# UNITED STATES PATENT AND TRADEMARK OFFICE

| APPLICATION NO. | FILING DATE | FIRST NAMED INVENTOR | ATTORNEY DOCKET NO. | CONFIRMATION NO. |
|-----------------|-------------|----------------------|---------------------|------------------|
| 09/960,615      | 09/21/2001  | Joseph Yoder         | 61773.02101         | 7143             |

**Office Action Summary**

## DETAILED ACTION

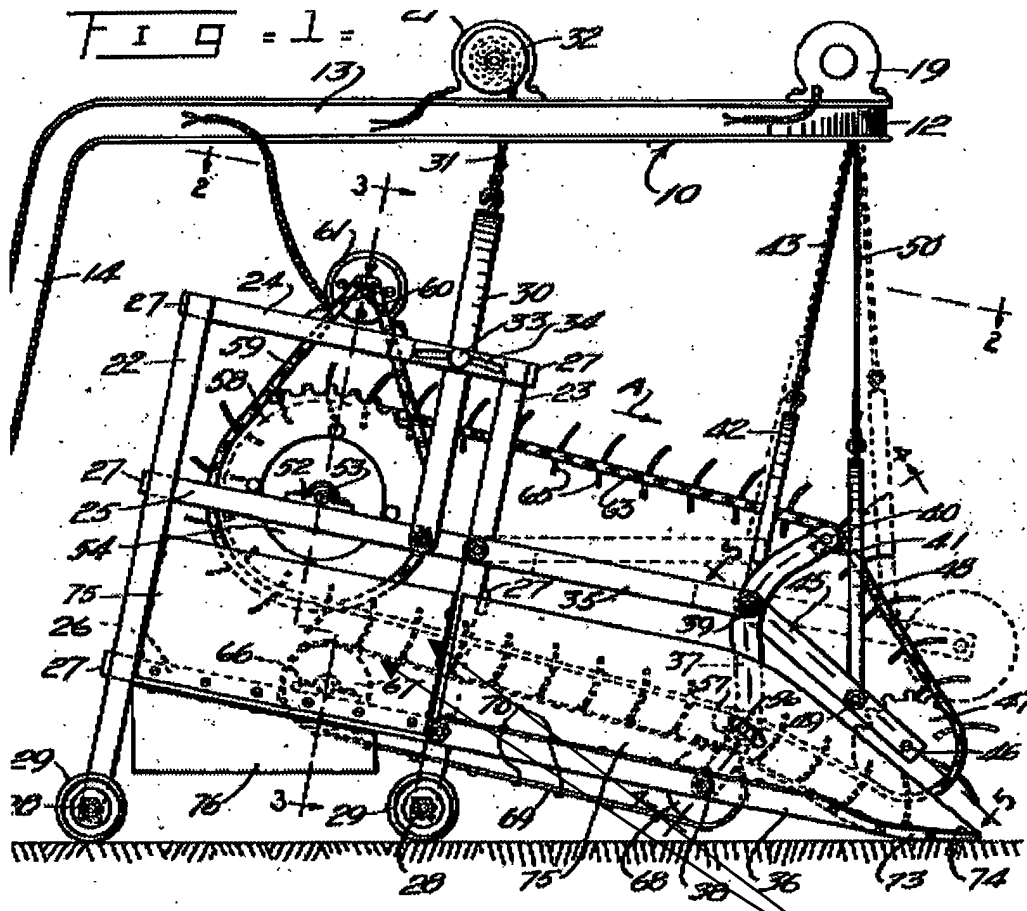
Applicant's argument regarding the "specification lacks antecedent basis for the spacing between the bars," is not agreed with, since the Applicant mischaracterizes the rejection made, also see detailes above.

Arrays/webs generally upstanding  
(Polisena)

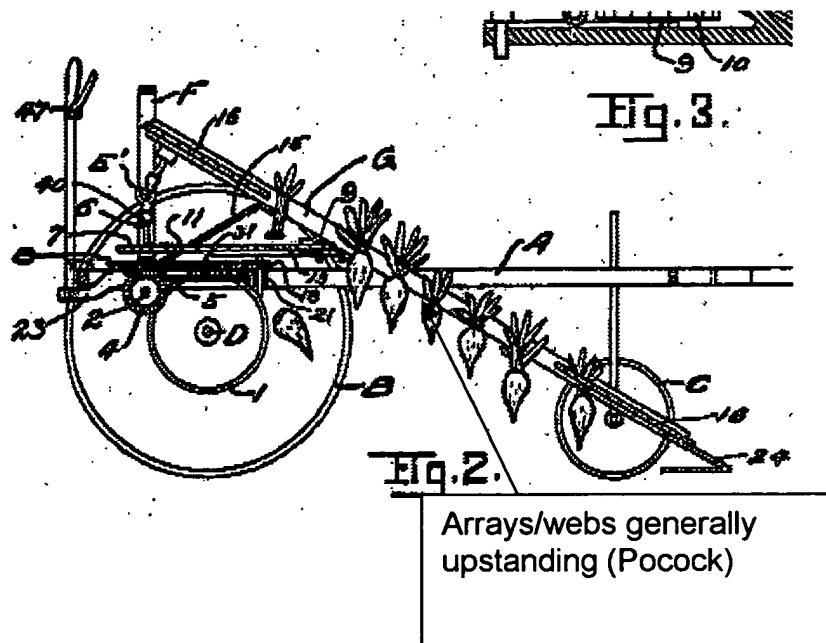
Applicant's argument in re claims 1, 13, 34, 35, that the arrays/webs are not upstanding in the cited prior art is not agreed with, because as shown below the arrays & webs are indeed generally upstanding as claimed.
